Addendum #3

Project Name: Indiana State University – Dreiser Hall Renovation

Project #: 19052

Date: June 26, 2020

1 Floor Plan
3rd Floor Plan
A1.03 1/8" = 1'-0"

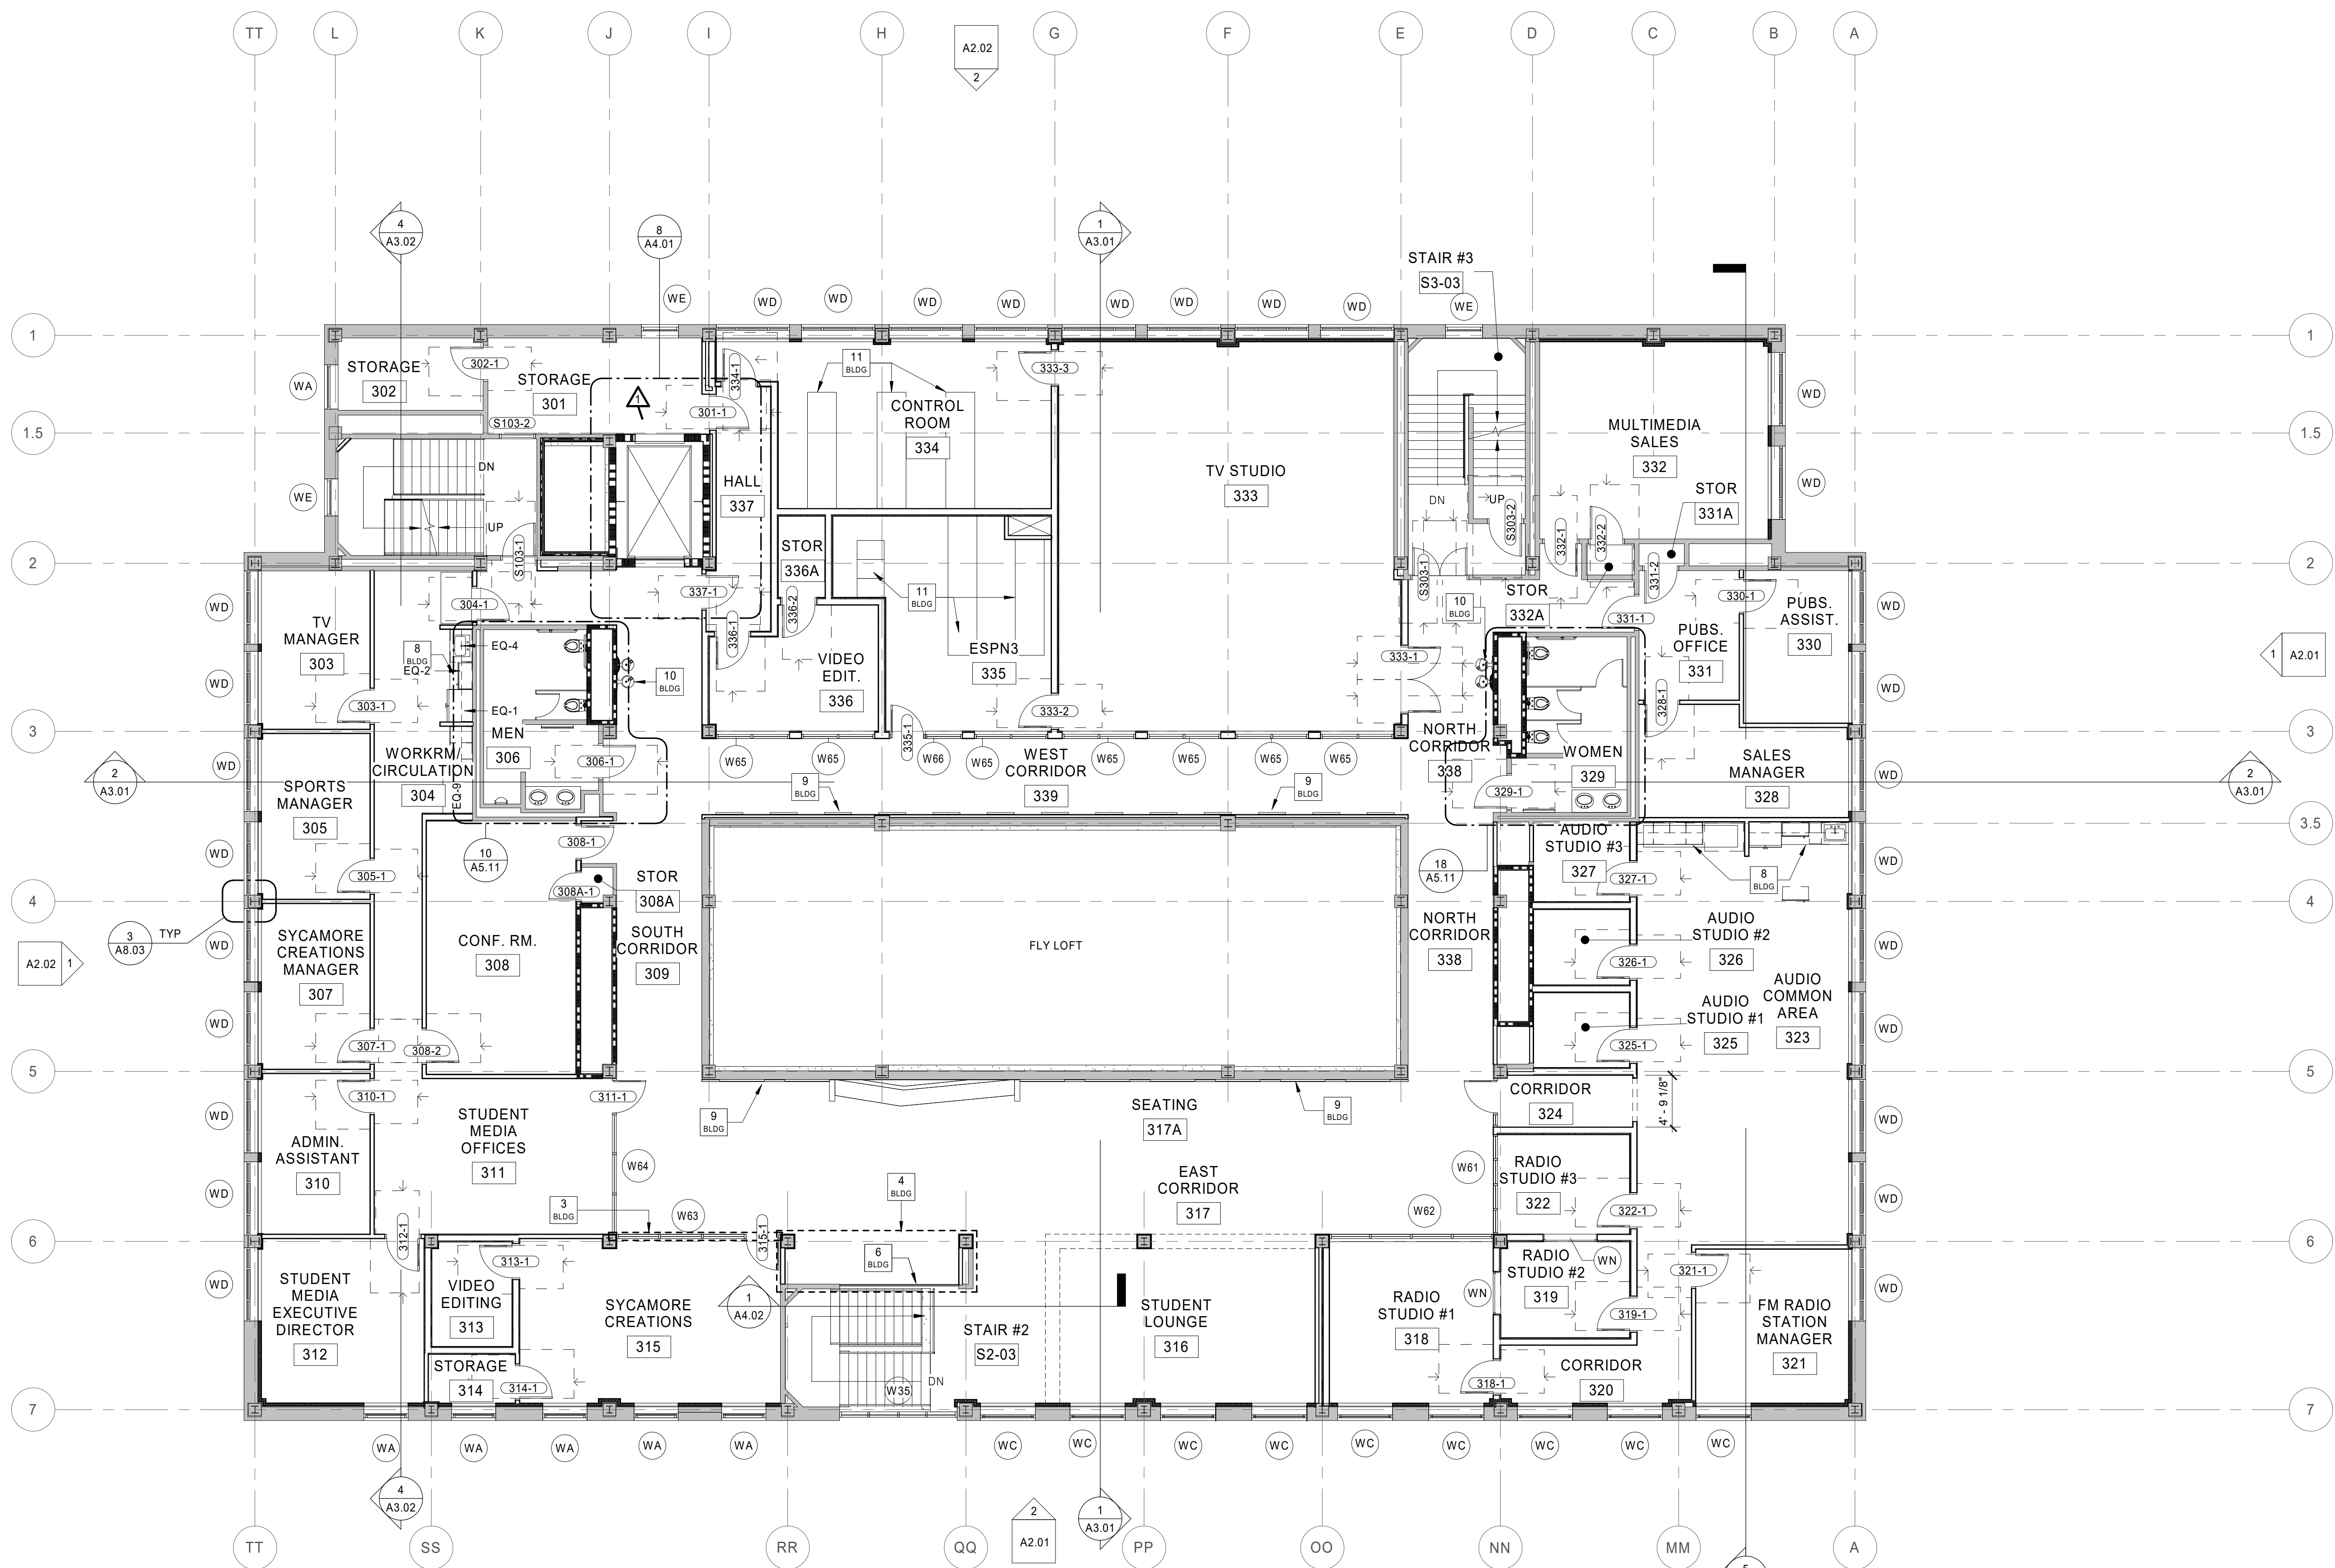
18. Sheet A1.03 – 3rd Floor Plan
- A. Reissue sheet – see clouds
- B. Revised Coded Notes
19. Sheet A1.03B – 3rd Floor Reflected Ceiling Plan
- A. Revise Coded Ceiling Note 5. to read: “ALTERNATE #4 – PROVIDE PIPE GRID CEILING AND THEATRICAL LIGHTING. SEE ELECTRICAL DRAWINGS FOR MORE DETAILS. BASE BID – NO PIPE GRID OR THEATRICAL LIGHTING. PROVIDE THEATRICAL CURTAIN.

1 Floor Plan
Roof Plan
A1.05 1/8" = 1'-0"

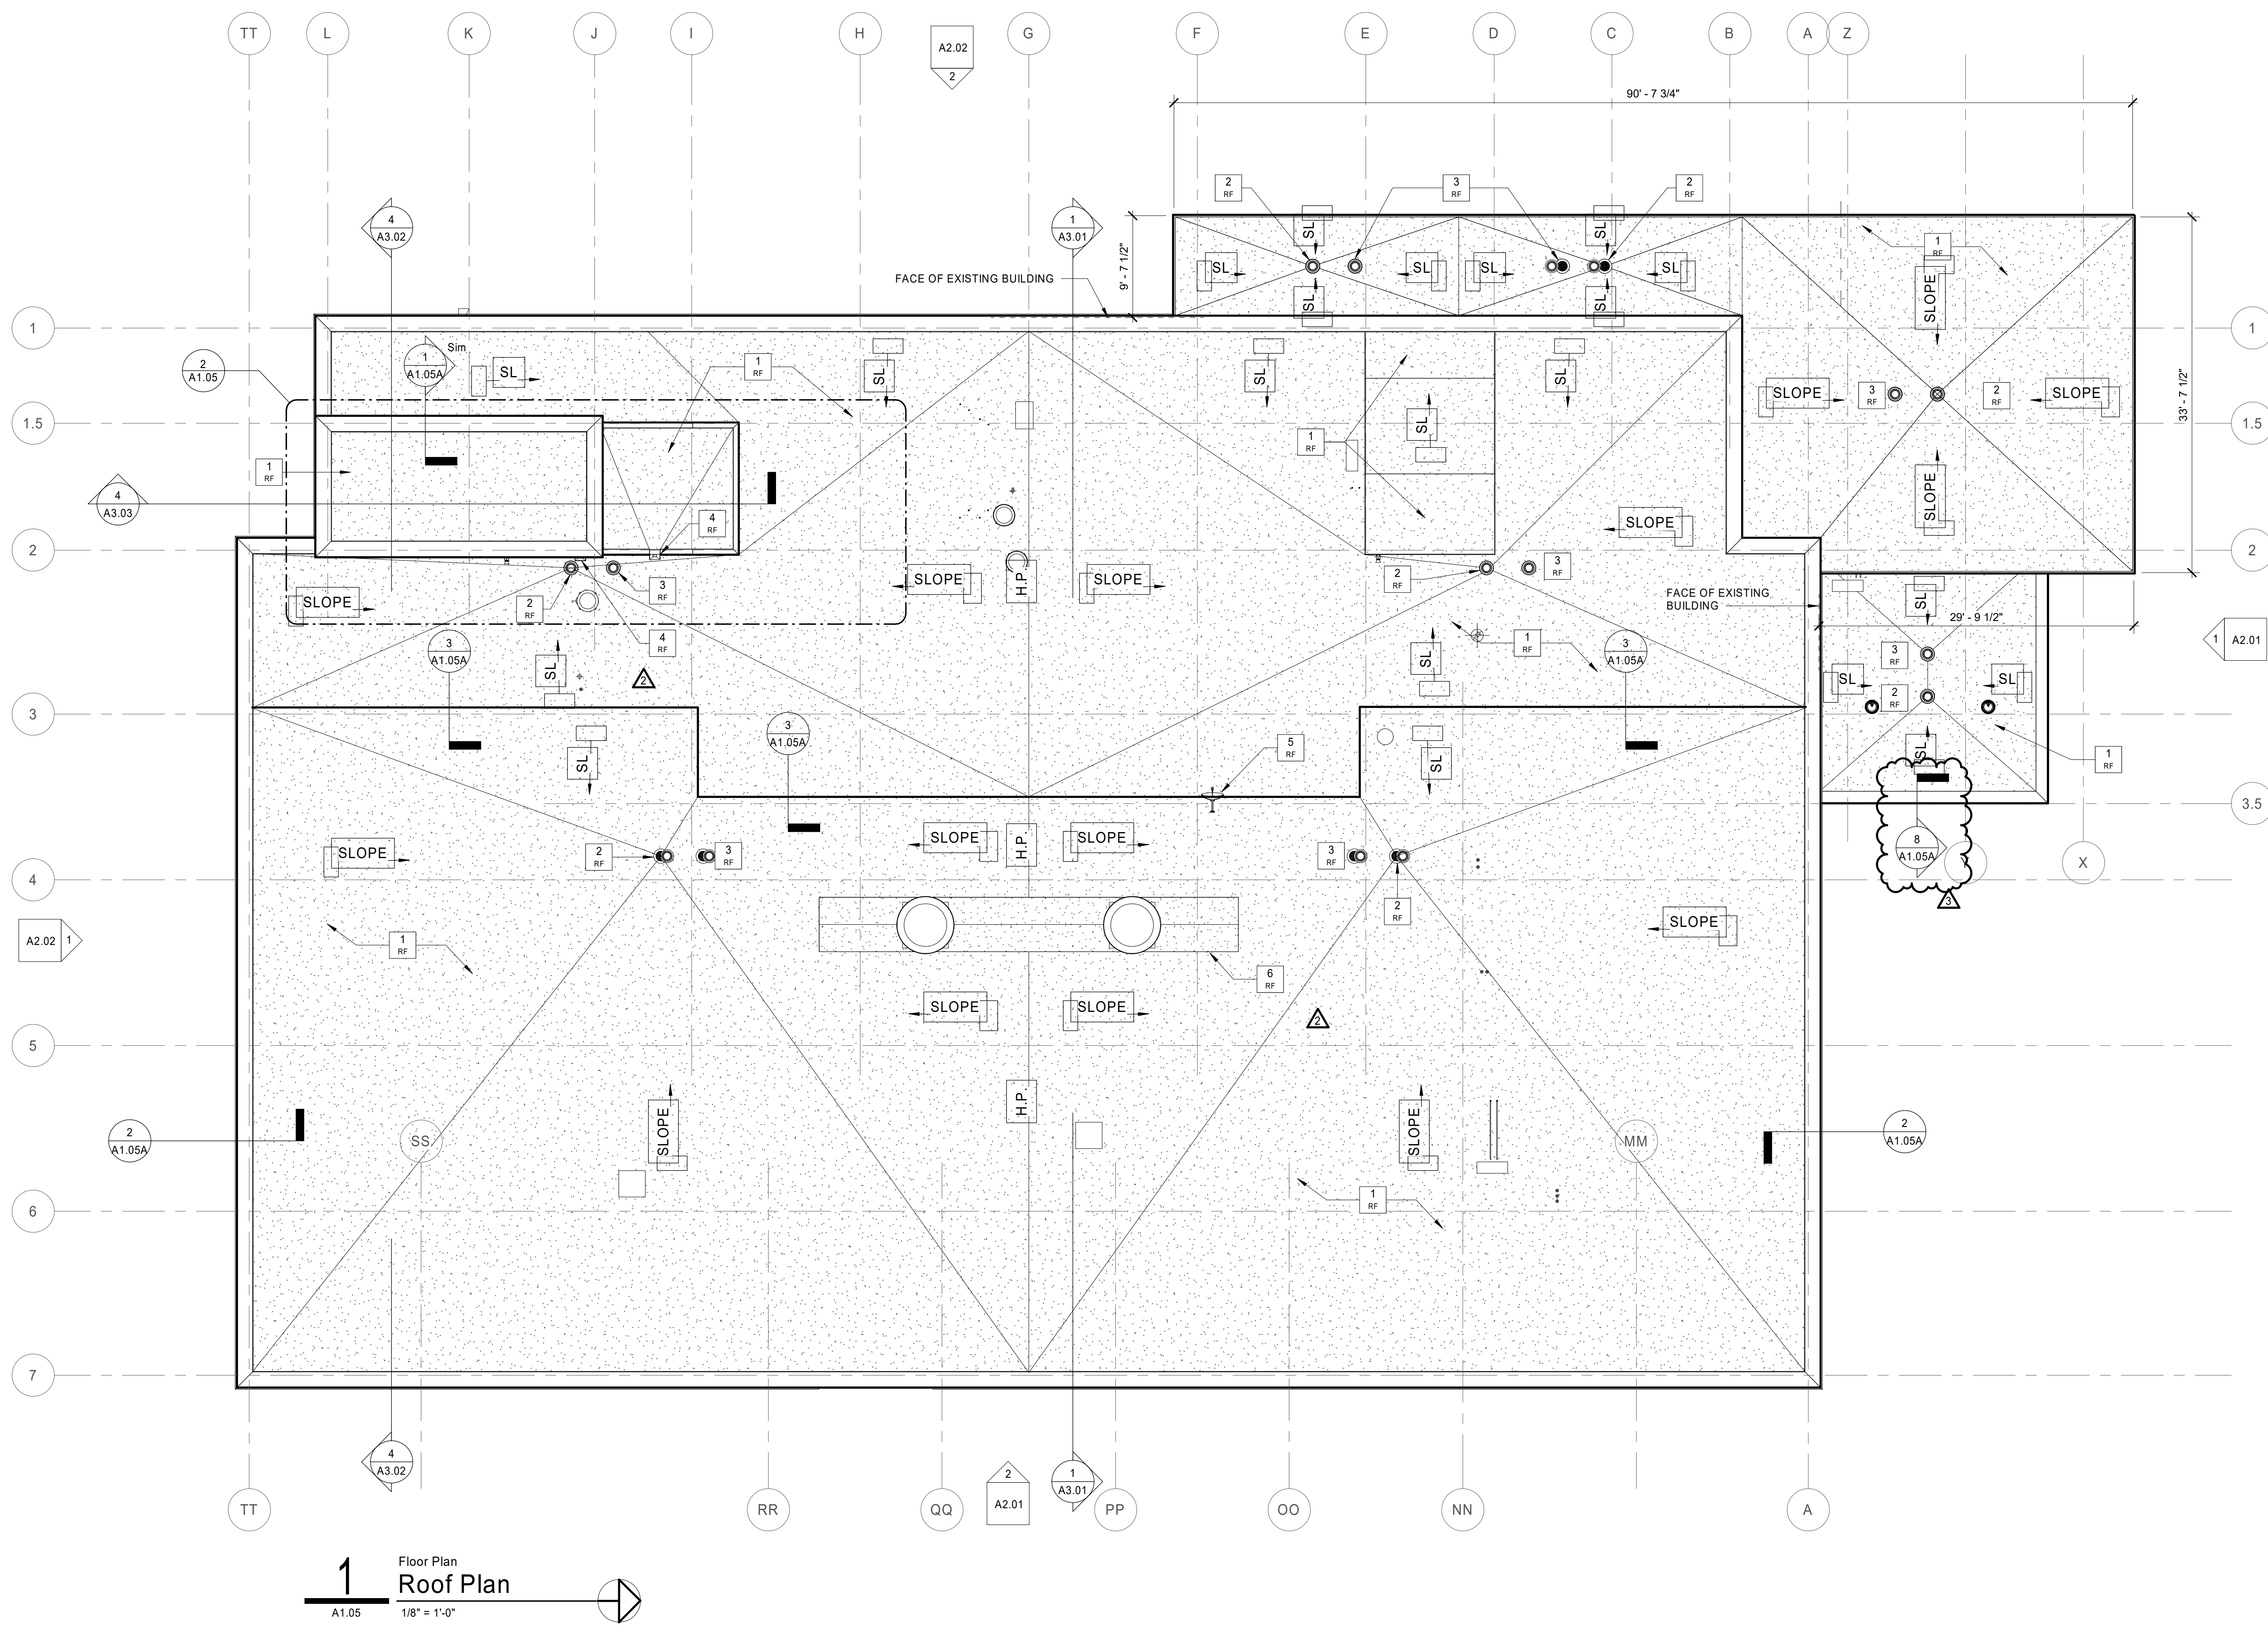
20. Sheet A1.05 – Roof Plans
- A. Reissue sheet – see clouds
